DEVELOPMENT DETERMINATION PANEL MEETING

WEDNESDAY 25 MAY 2022

ITEM 3.1	DA2021/1636 - 7 CROWN ROAD QUEENSCLIFF - ALTERATIONS AND ADDITIONS TO A DWELLING HOUSE
REPORTING MANAGER	Steve Findlay
TRIM FILE REF	2022/298193
ATTACHMENTS	1 ↓ Assessment Report 2 ↓ Site Plan and Elevations 3 ↓ Clause 4.6

Application Number:	DA2021/1636
Responsible Officer:	Daniel Milliken
Land to be developed (Address):	Lot 2 DP 514296, 7 Crown Road QUEENSCLIFF NSW 2096
Proposed Development:	Alterations and additions to a dwelling house
Zoning:	Warringah LEP2011 - Land zoned R2 Low Density Residential Warringah LEP2011 - Land zoned RE1 Public Recreation
Development Permissible:	Yes - Zone R2 Low Density Residential Yes - Zone RE1 Public Recreation
Existing Use Rights:	No
Consent Authority:	Northern Beaches Council
Delegation Level:	DDP
Land and Environment Court Action:	No
Owner:	Andrew James Formica
Applicant:	Dorn Design
Application Lodged:	15/09/2021
Integrated Development:	No
Designated Development:	No
State Reporting Category:	Residential - Alterations and additions
Notified:	23/09/2021 to 07/10/2021
Advertised:	Not Advertised
Submissions Received:	4
Clause 4.6 Variation:	4.3 Height of buildings: 15.3%

Bedroom level detail

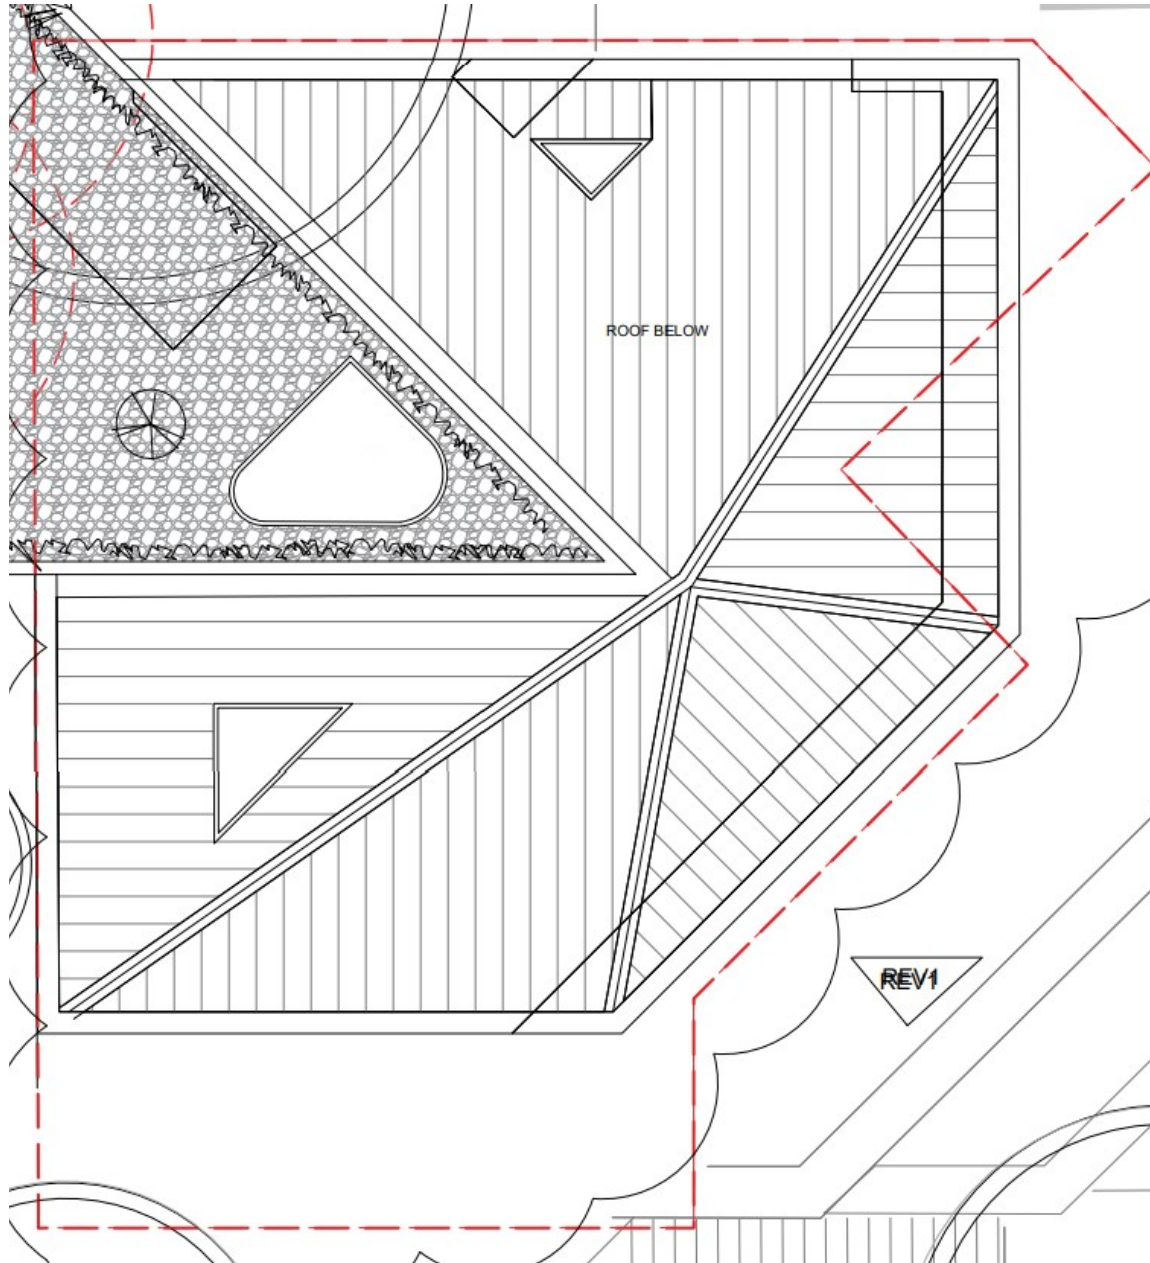
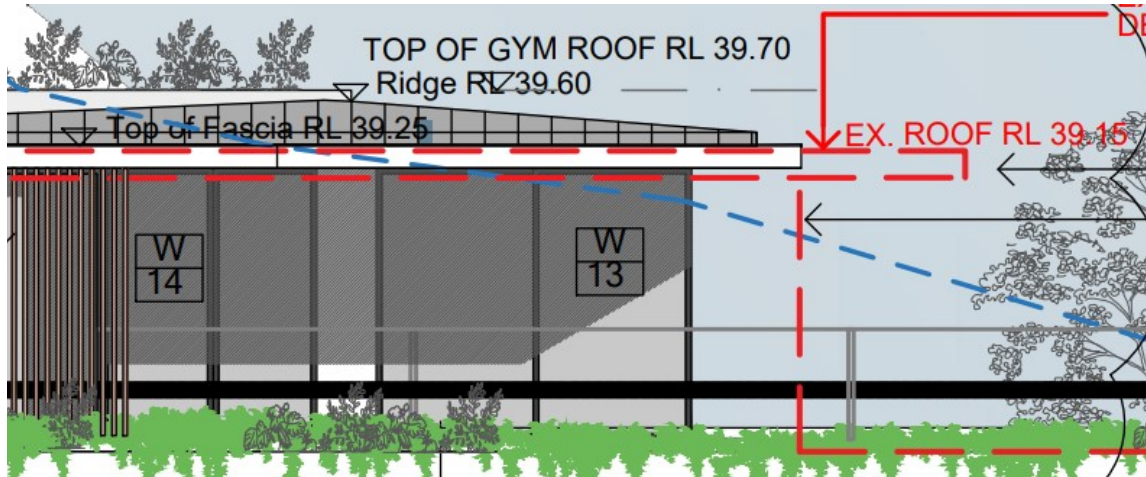
The 'bedroom' level is critical to the assessment of views, height and side boundary envelope. It is a major point of contention with the objectors.

In the image below, the red dotted line is the outline of the existing 'bedroom' level overlayed onto the proposed level. It is clear that in some areas, bulk is being removed, and in others added.

The other key piece of information about this level is the maximum RL of the outer (righthand side in the images above and below) edge of the roof. The existing outer edge of the roof is at RL 39.15 and the proposed outer edge is RL 39.25, a 10mm difference. This is most relevant to the assessment of view sharing under Part D7 Views, below in this report.

4.3 Height of buildings

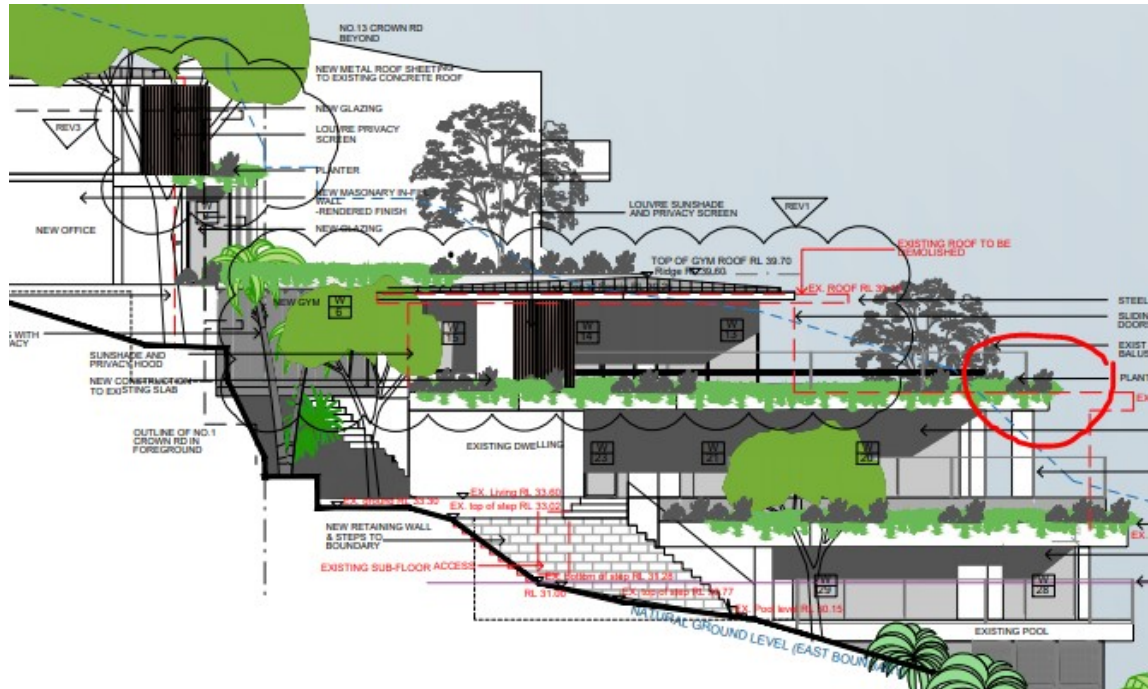
The portion of the dwelling that breaches the height limit is not on the garage (top) level or the upper most level of the dwelling proper. The highest point above natural ground level is at the outer edge of the 'living' level, circled red, below.

It is noted that the alterations to this level reduce the maximum height of the building by demolishing the triangular outer edge of the existing balcony, shown above and circled red in the demolition plan, below.

Description of non-compliance:

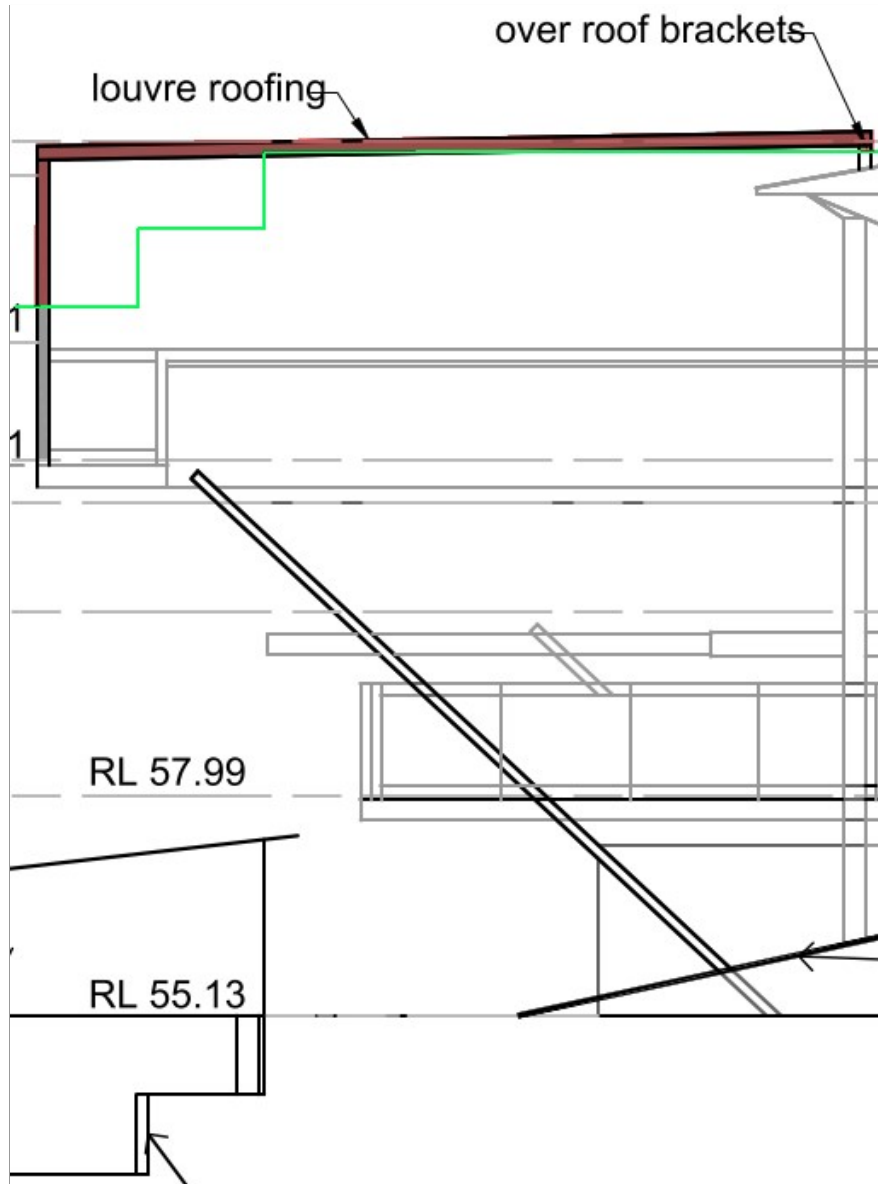
Development standard:	Height of Buildings
Requirement:	8.5m
Proposed:	10.3m
Percentage variation to requirement:	21.17%

The extent of the variation to the height of buildings development standard is shown below, with the green line indicating the 8.5m maximum height, and the red highlighting the portion breaching the standard:

Figure 1. North Elevation (red line showing building height non-compliance)

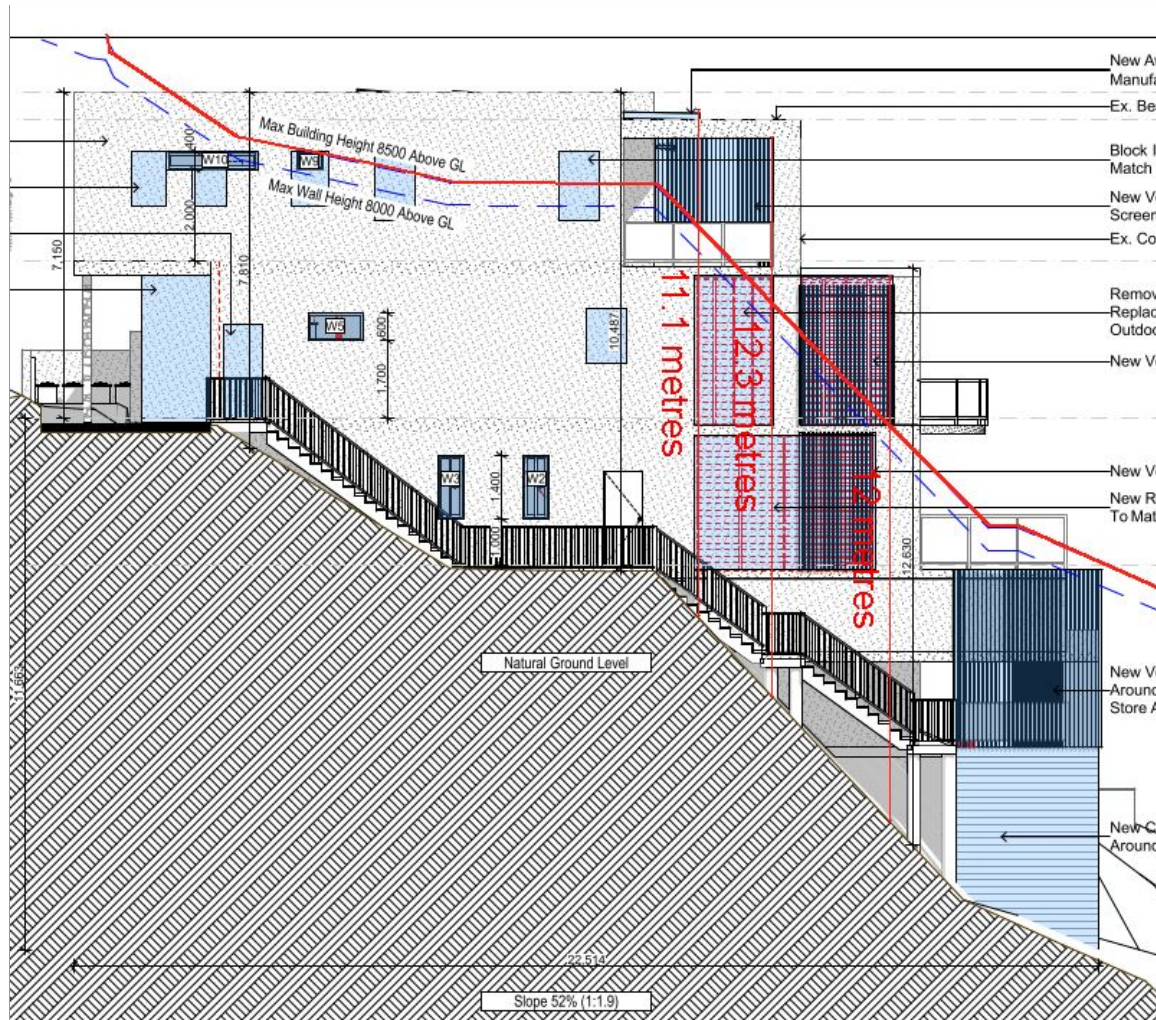
Development standard:	Height of buildings
Requirement:	8.5m
Proposed:	12.3m
Percentage variation to requirement:	44.71% (3.8m)

Figure 3. North Elevation (Proposed works in blue and above red line indicates numerical Wall Height non-compliance)

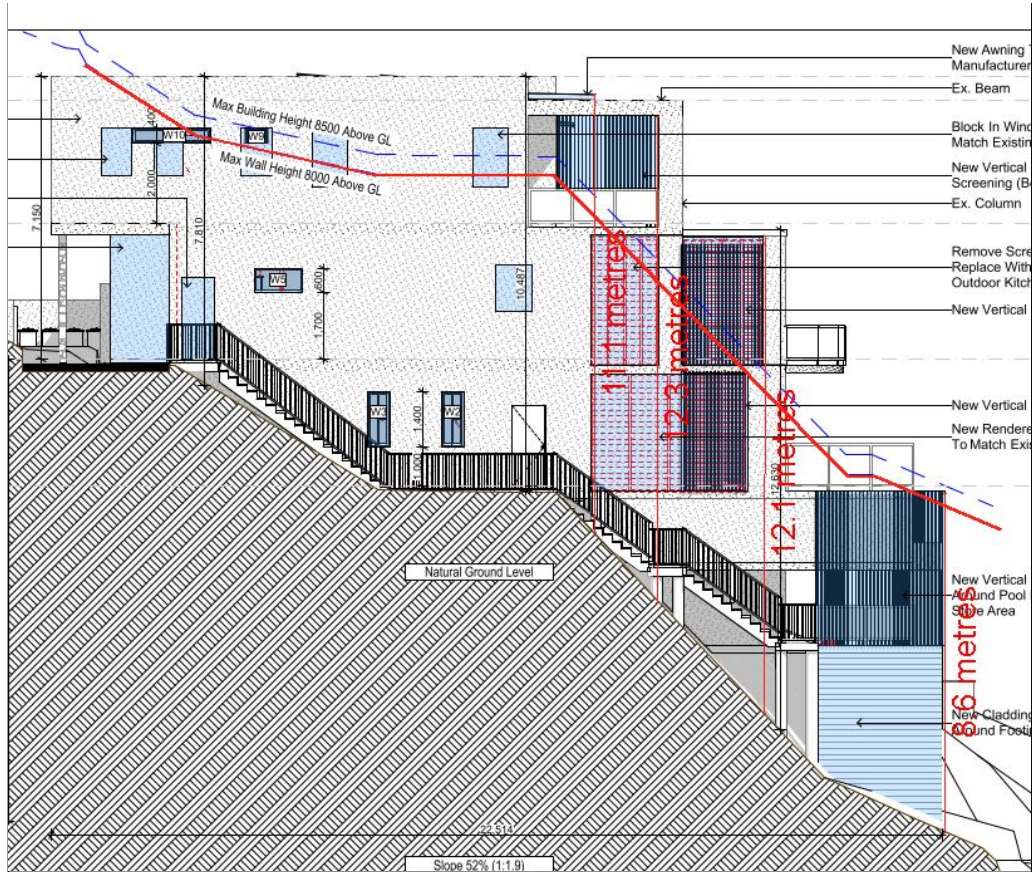
Due to the sloping topography, the wall height varies across the differing floors. The maximum proposed wall height is 12.3m along both the northern wall as a result of the privacy screen on the first floor. The northern façade obtains a numerically non-compliance to the wall height control presenting a variation of 7.5% to the lower ground floor, 51.25% to the ground floor, and 53.75% to the first floor (see Figure 3).

Figure 2: elements outside of prescribed envelope

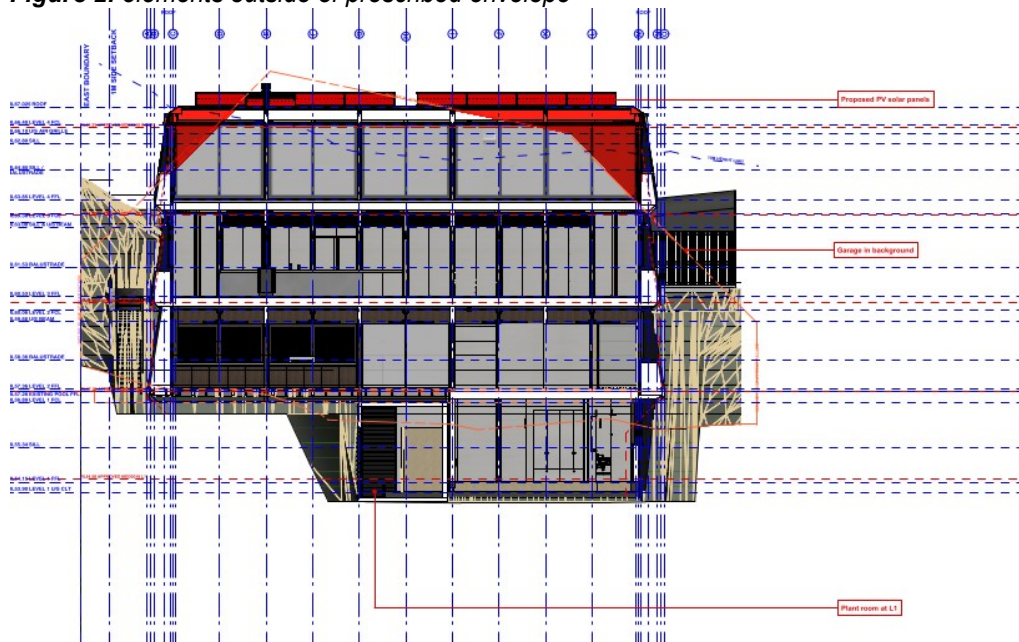
The modified proposal increases the building height from RL 66.33 to RL 67.025 AHD and involves additional upper floor minor elements that protrude outside of the prescribed envelope. Figures 2 and 3 below depicts the components of the building that protrude outside of the prescribed envelope and the additional areas of non-compliance.
